SUBJECT: SUBMITTAL OF THE RESPONSE TO THE NOTICE OF DISAPPROVAL FOR THE INVESTIGATION REPORT FOR THE TA-16-340 COMPLEX [CONSOLIDATED UNITS 13-003(a)-99 AND 16-003(n)-99 AND SOLID WASTE MANAGEMENT UNITS 16-003(o), 16-026(j2), AND 16-029(f)]

**Response to the
Notice of Disapproval for the Investigation Report for the TA-16-340 Complex
[Consolidated Units 13-003(a)-99 and 16-003(n)-99 and
Solid Waste Management Units 16-003(o), 16-026(j2), and 16-029(f)]
Los Alamos National Laboratory, NM0890010515 HWB-LANL-06-005,
Dated September 14, 2006**

Figure 1. Additional sampling locations at the 340 Complex

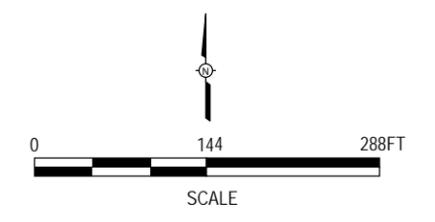
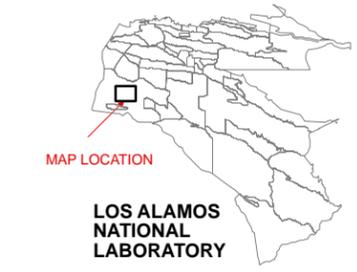
The Permittees claim that the vertical extent of cobalt is defined within Fishladder Canyon by the two intermediate-depth boreholes (Locations 16-23691 and 16-23692). The cobalt detection at locations 16-23693 and 16-23749 (two sample locations most downgradient from the fishladder) are above background levels in tuff (84.6 ppm and 89.9 ppm, respectively). These elevated detections are approximately 1,200 feet downgradient from location 16-23692. It is not appropriate to use data collected from 1,200 feet away to determine vertical extent. The Permittees must determine vertical extent of cobalt at locations 16-23693 and 16-23749.

The Permittees also claim that vertical extent of silver is defined at SWMU 16-003(o). Silver was detected in a tuff sample collected at 2.8-3.5 feet below ground surface at location 16-23693. The concentration detected was greater than four times the background level. Because this is the deepest sample that was collected in this part of the SWMU and location 16-23692 is too far away (approximately 1,200 feet) to be used to determine vertical extent, the Permittees must collect additional samples to determine vertical extent for silver at this location.

The Permittees state that several organic compounds were detected in fill and/or tuff at several locations along the former Building 340 drainline. The Permittees also state that the vertical extent of these contaminants has been defined with the deepest interval in borehole 16-23691. The closest sampling location to borehole 16-23691 along the drainline is approximately 360 feet upgradient. It is not appropriate to use data collected from this borehole to determine vertical extent along the drainline. The Permittees must collect additional samples along the drainline to determine extent for these contaminants.

At sampling locations along the drainline from former 16-340 building, the concentrations of several constituents increase with depth. The Permittees must determine extent of these contaminants at the following locations.

Because of the lateral extent of contamination and the increasing contaminant concentrations with depth along the former drainline from building 340, the Permittees must also determine if there are VOCs in pore gas in this area. Specifically, a deep boring (total depth to be determined based on field screening) must be located near sampling locations 16-24894, 16-26896, 16-24899, and 16-24891. The Permittees must follow the pore-gas sampling procedures as described in the approved work plan.

9. Per a discussion with NMED on September 14, 2006, LANL will drill more deeply at location 16-23693 to determine the nature and extent of metals contamination (specifically, cobalt and silver), assuming drilling equipment can access this difficult location (see Figure 1). These data will also help to determine whether the cobalt contamination is the result of spalling from the auger used in the previous investigation.

10. Per a discussion with NMED on September 14, 2006, LANL will drill an intermediate-depth borehole in the vicinity of these locations as requested by NMED comment 13 to effectively determine the extent of polycyclic aromatic hydrocarbons (PAHs) in this area. Consequently, the additional sampling requested is addressed by this additional intermediate-depth borehole (see Figure 1).

- Individual locations 16-24891, 16-24894, 16-24896, and 16-24899 will not be resampled; however, the new intermediate-depth borehole requested in NMED comment 13 will be drilled in the vicinity of these locations (see Figure 1). The data collected from the borehole soil and tuff samples will be used to define the extent of HE compounds at these locations. Also, no additional samples will be collected at location 16-23609. LANL is already proposing a 15-ft borehole at location 16-23597 (approximately 108 ft northwest of 16-23609) and a 15-ft borehole at the new location between sumps 105 and 106/107 (approximately 54 ft southeast of 16-23609).

Figure 2a. VOC pore-gas results, BH 16-23691

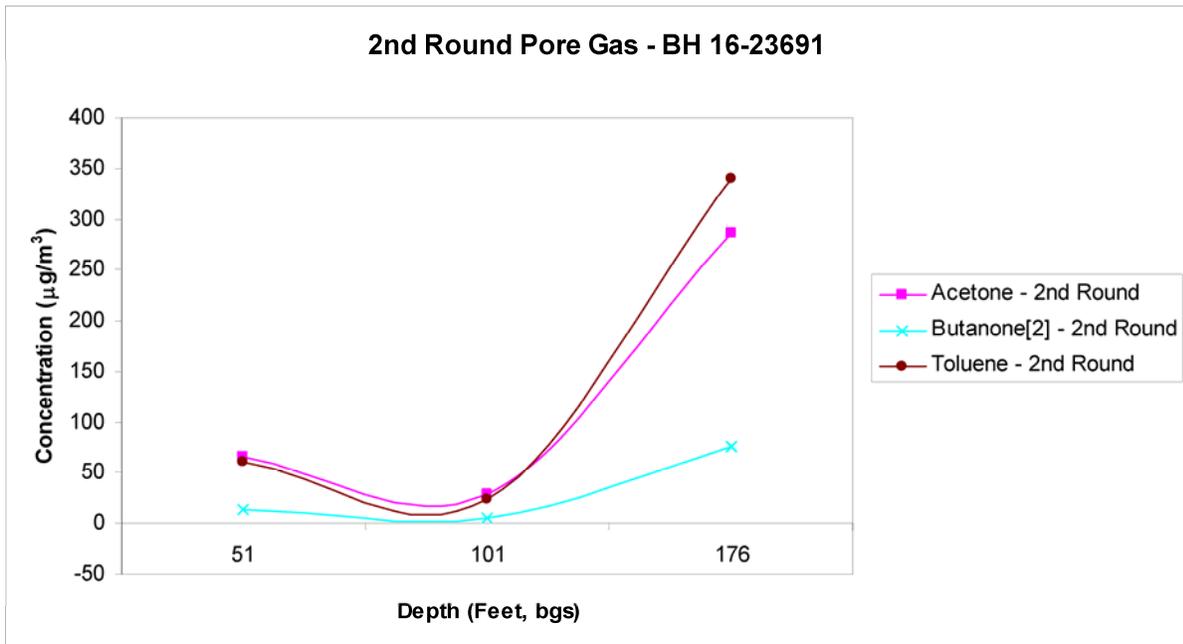
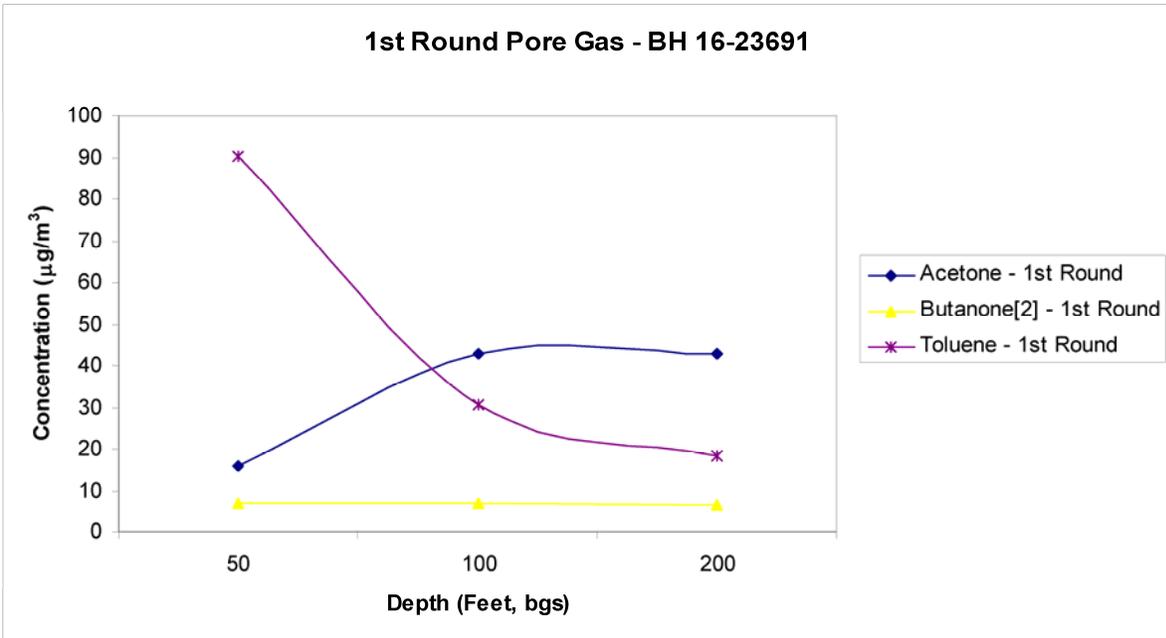
The Permittees state that the “concentrations tended to increase with depth and increased from the first round to the second round.” The Permittees must graphically present this information (and any

subsequent sampling data) to clearly show any trends for each borehole because the contamination trends with depth and time are not clear from the data presentation.

4. LANL has prepared graphs (Figures 2a and 2b) for the first and second pore-gas sampling events at each intermediate-depth borehole (BH 16-23691 and BH 16-23692) to illustrate the contamination trends, with depth, of selected volatile organic compounds (VOCs) (acetone, butanone[2], and toluene). Similar graphs will be generated for subsequent sampling data and will be provided in the Phase II report.
